**MARSTON GATE EXPANSION
CENTRAL BEDFORDSHIRE**

ASSESSMENT ON TRANSPORTATION PROPOSALS

E3800-mars-acc-transreport-0219 rev0

Client: RIDGMONT PARISH COUNCIL

Title:
**Review of Potential M1 J13
Safety Improvement Works**

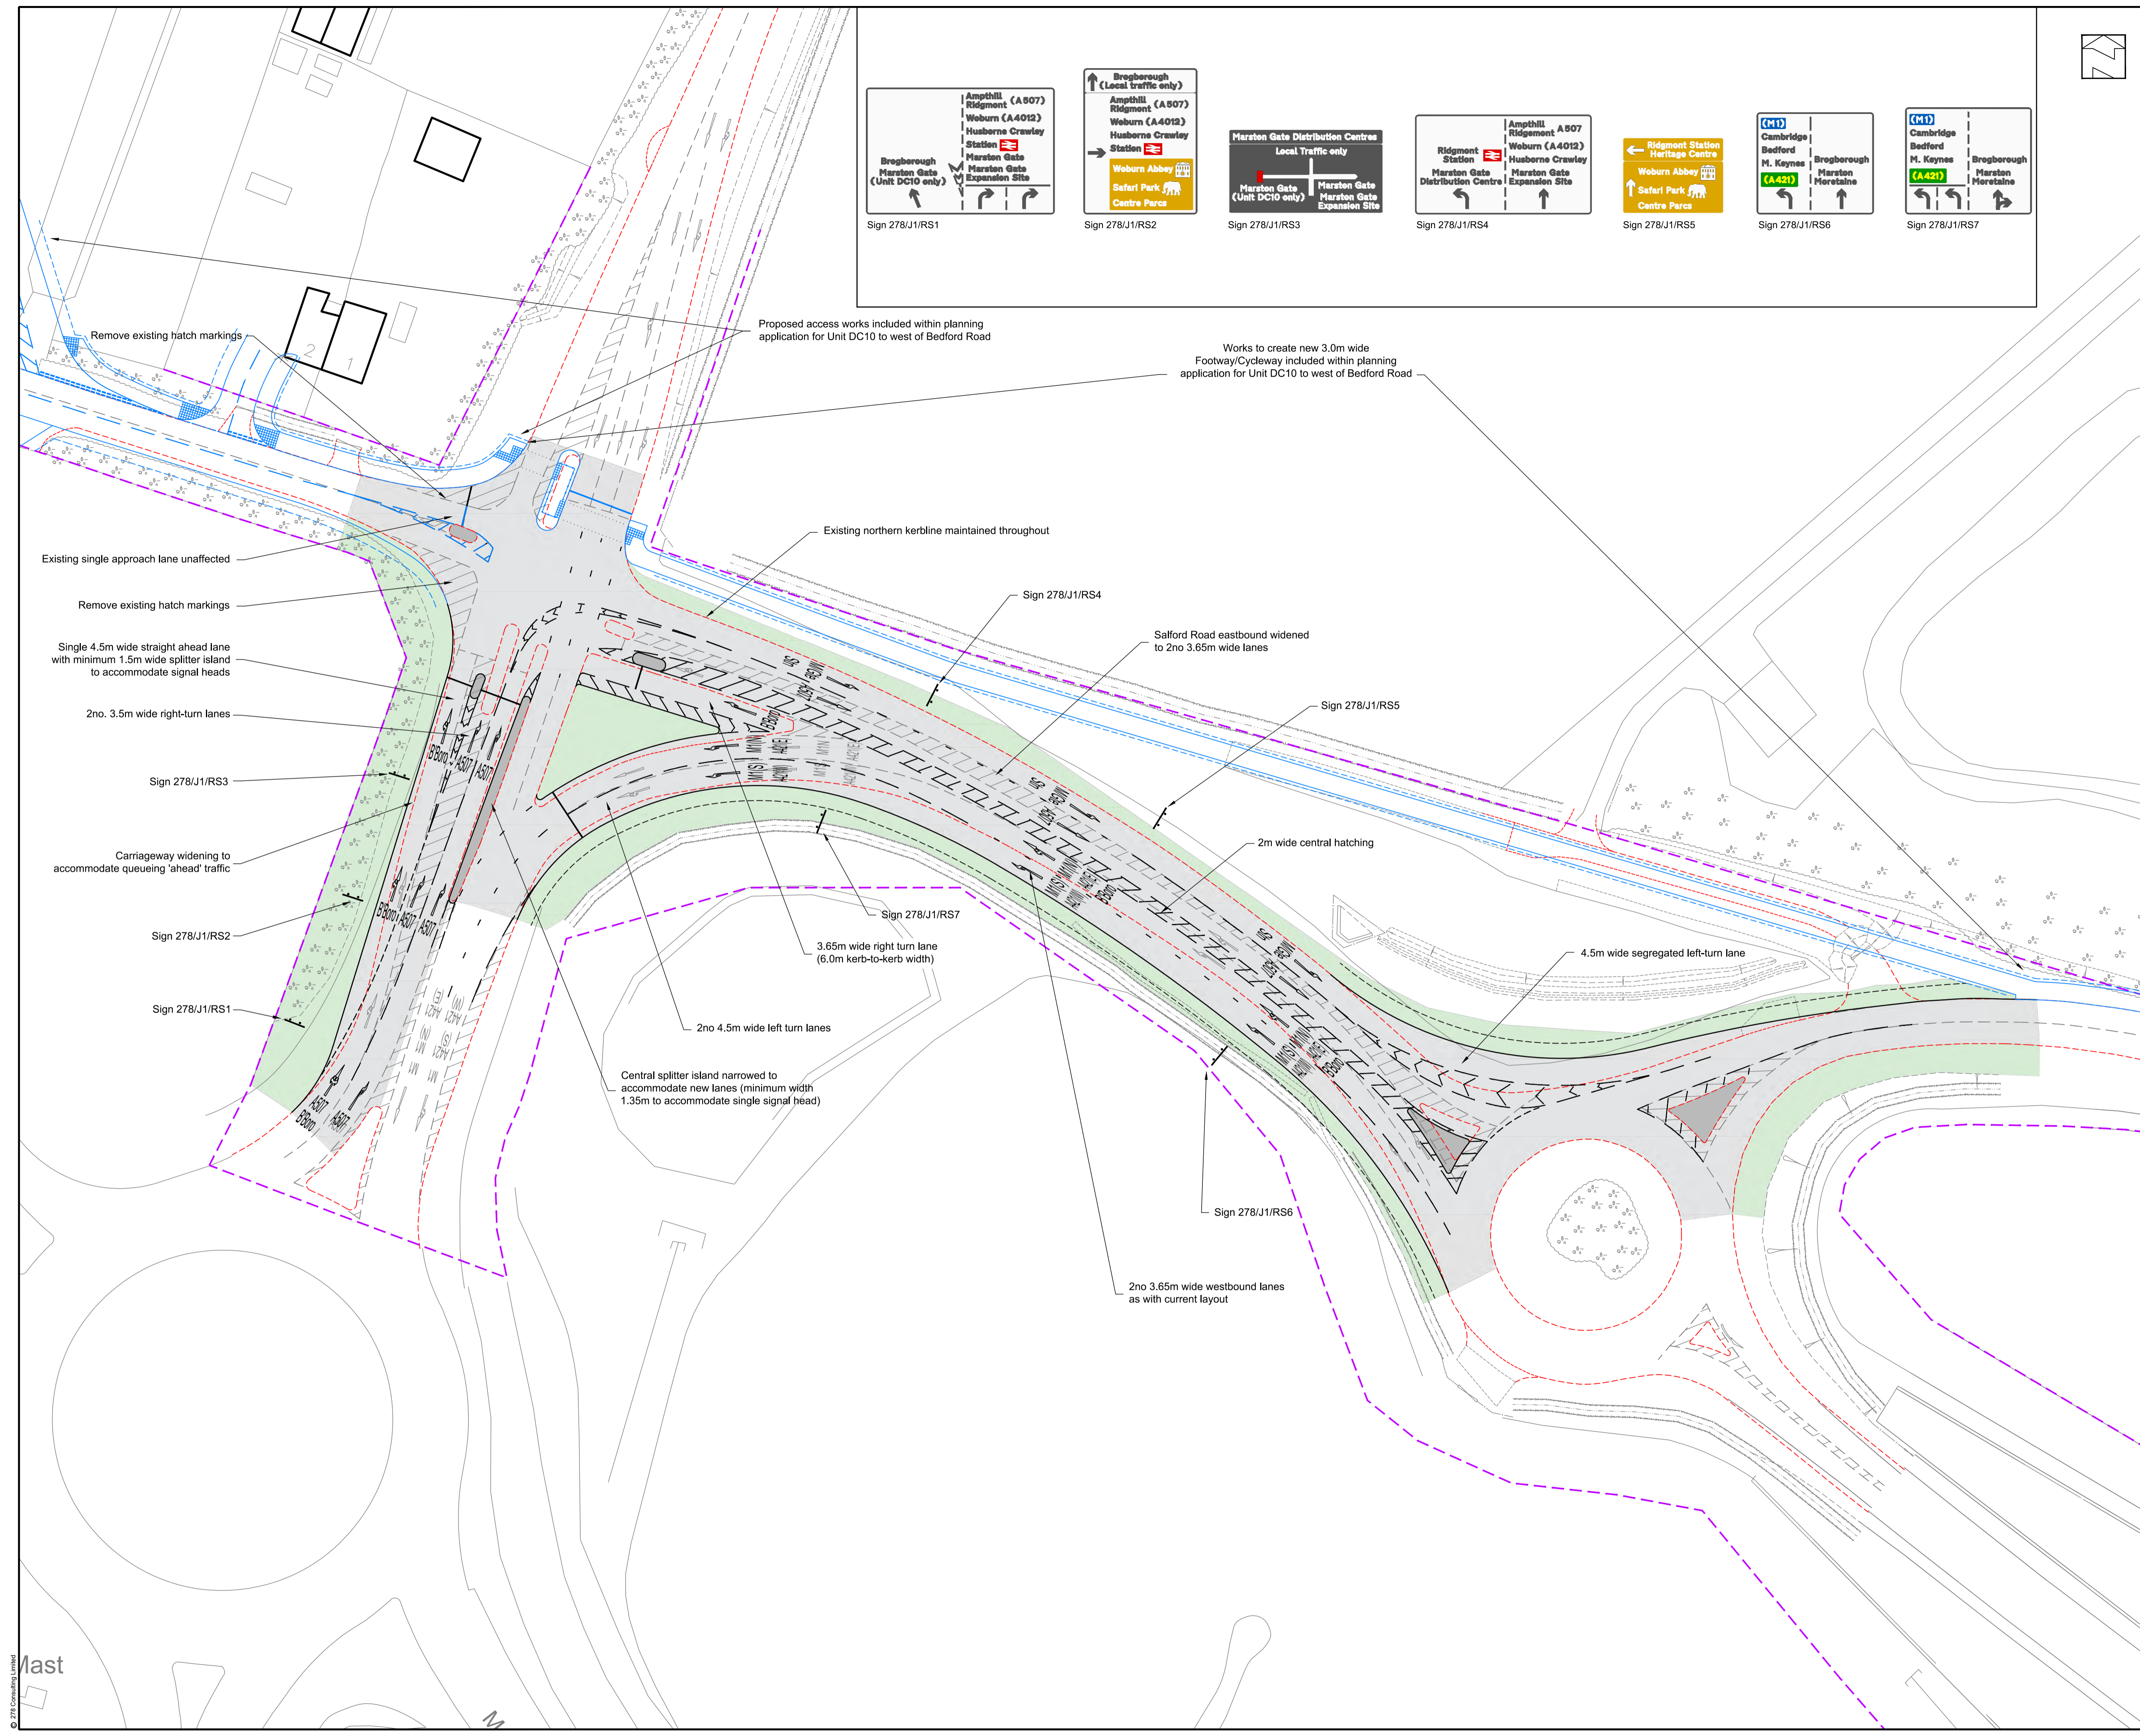
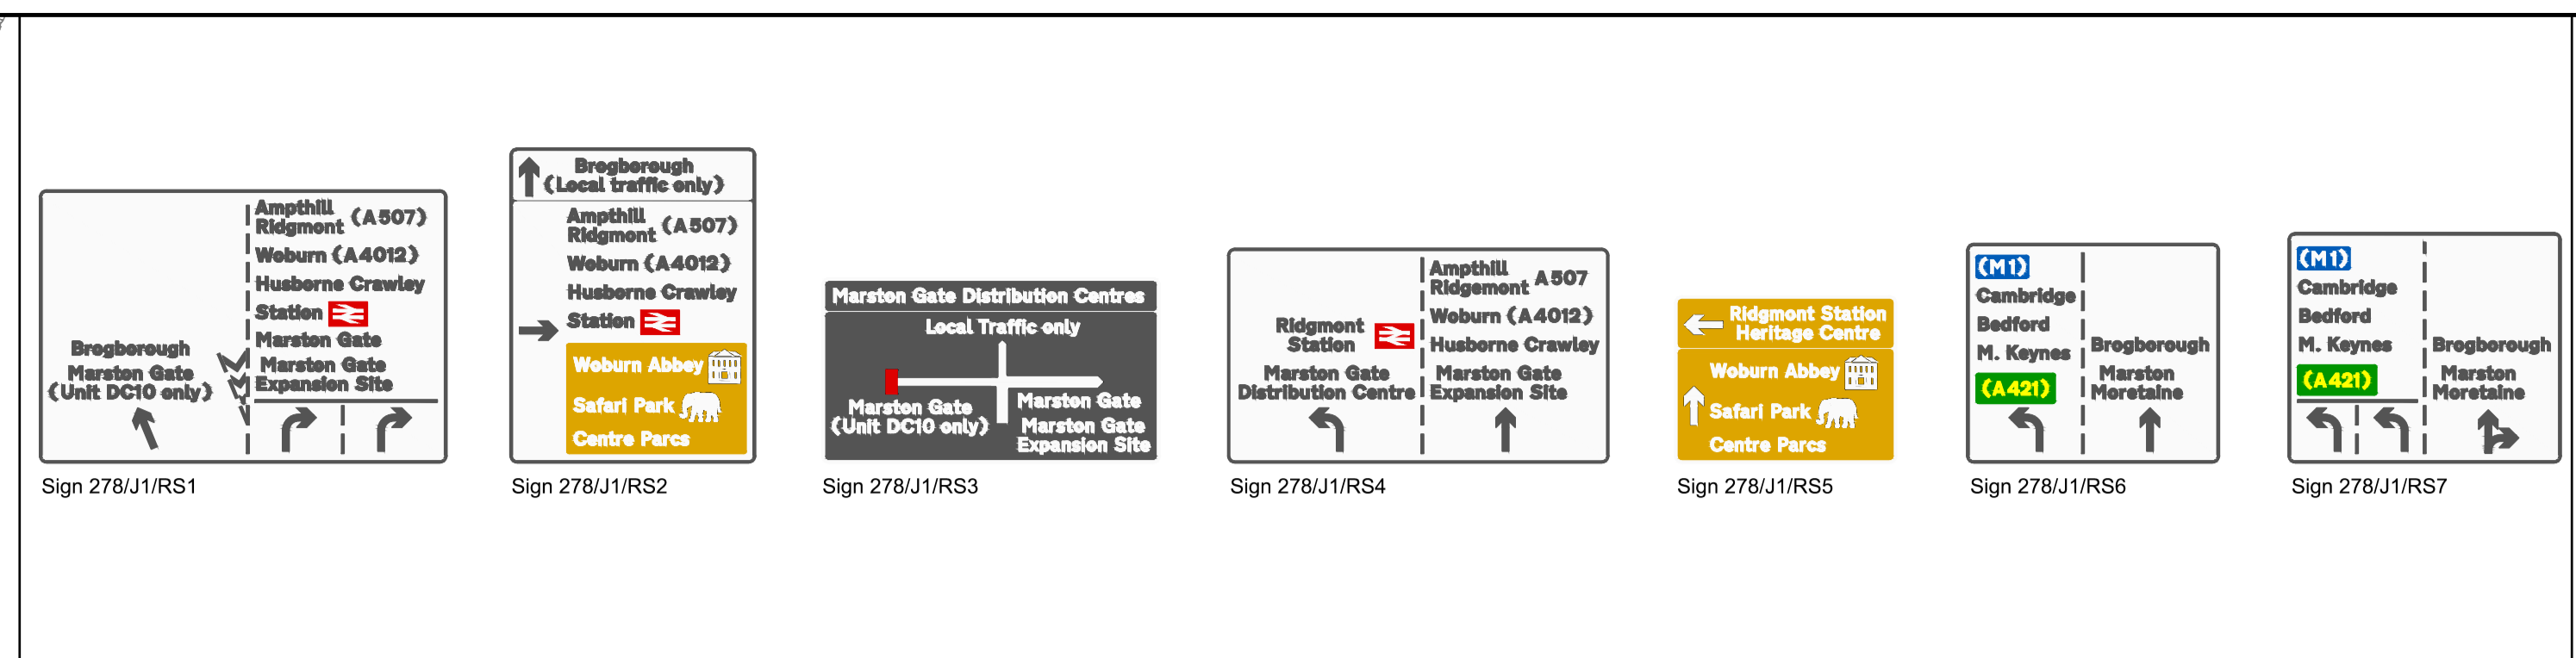
- 3.5.1 Off-site mitigation works are proposed to Junction 13 in the form of amending road markings on the offside lane allocation of the M1 northbound off-slip, to accommodate vehicle movements towards the A507 (Brogborough) only and remove the ability of access to the A421 towards Milton Keynes from the off-side

lane. This is shown in drawing 243/P/040 by 278 Consulting, a copy of which is placed in **Appendix B**, along with further alterations to road marking and white lining at the M1 J13 western and eastern roundabouts.

- 3.5.2 In Table 44 of the Transport Assessment, it states that this mitigation reduces the degree of saturation on the off-side lane in the PM peak in 2024 from 128.3% to 114.4%.
- 3.5.3 However, no indication has been given in the Transport Assessment that the current lane use has been observed and modelled. Therefore, it is possible that ahead traffic on the northbound off-slip could already be using only the nearside and centre lanes.
- 3.5.4 Validation of the existing lane use is thus required before any improvements to the operation of the off-slip can be claimed.
